ULNRC-656

DOCKET NUMBER 50-483
CALLAWAY PLANT, UNIT 1
TECHNICAL SPECIFICATION SECTION 6.0

SECTION 6.0

UE Submittal after 8/12/83
meeting with NRC

FIGURE 6.2-1
NUCLEAR FUNCTION
ORGANIZATION CHART

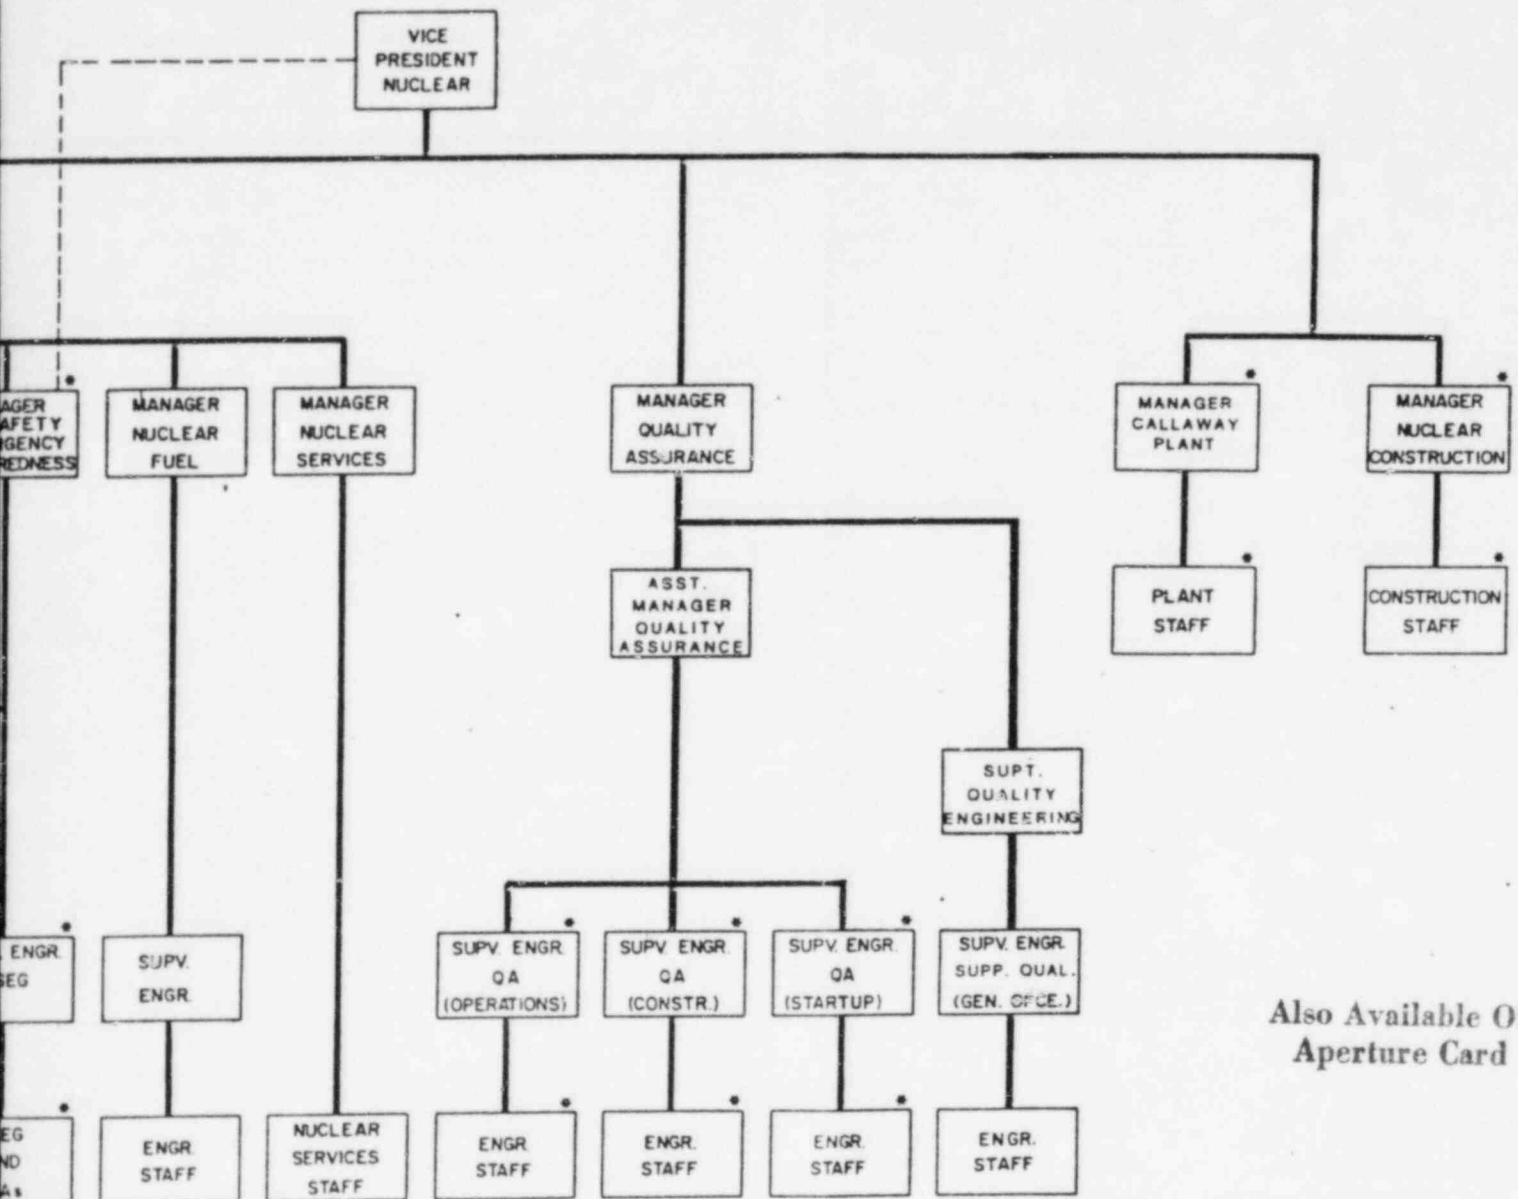
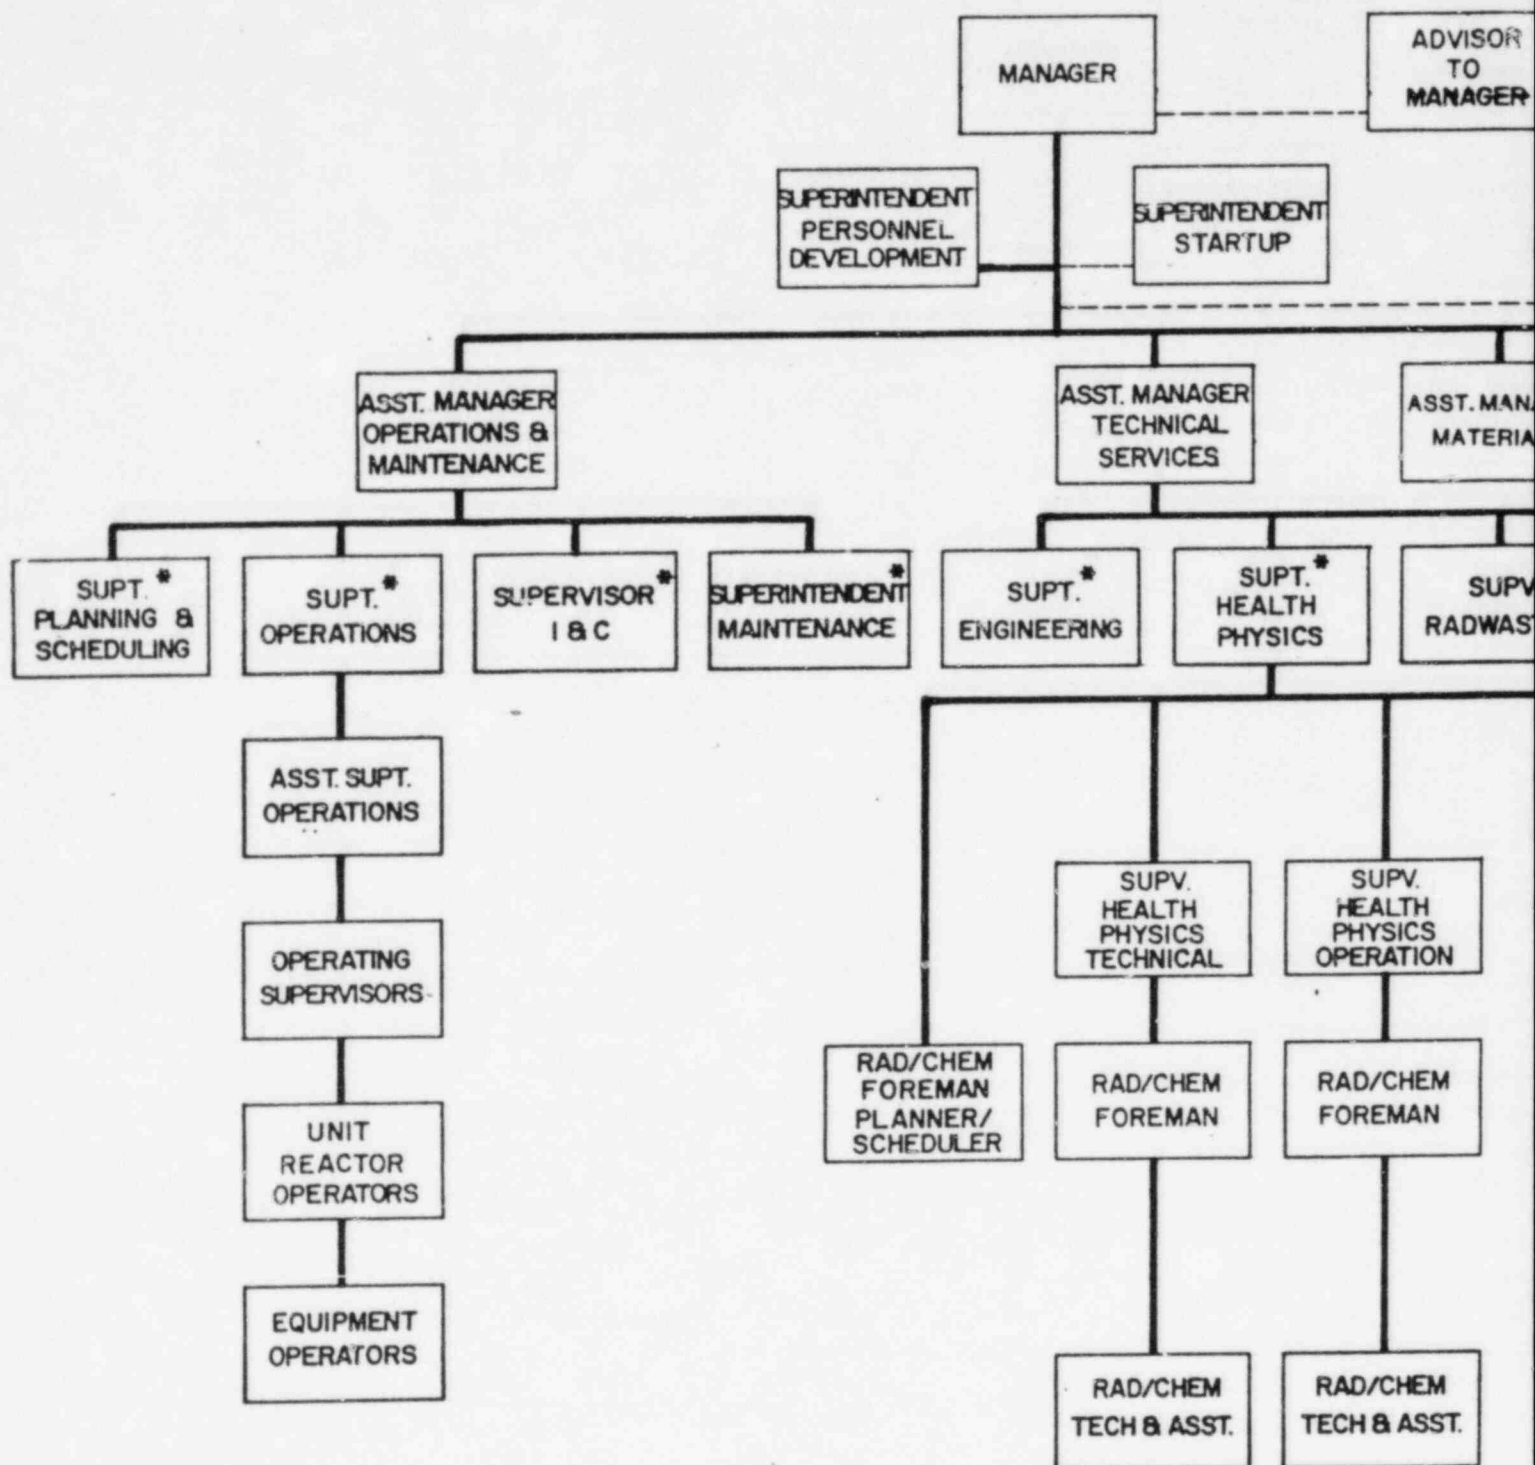
<u>Page No.</u>	<u>Section</u>	<u>Discussion</u>
6-6	6.3.1	UE has researched the letter of 3-28-80 and has incorporated NRC wording into this section.
6-3 & 6-4	Figs. 6.2-1 & 6.2-2	UE has updated these figures in this submittal and considers this item closed.
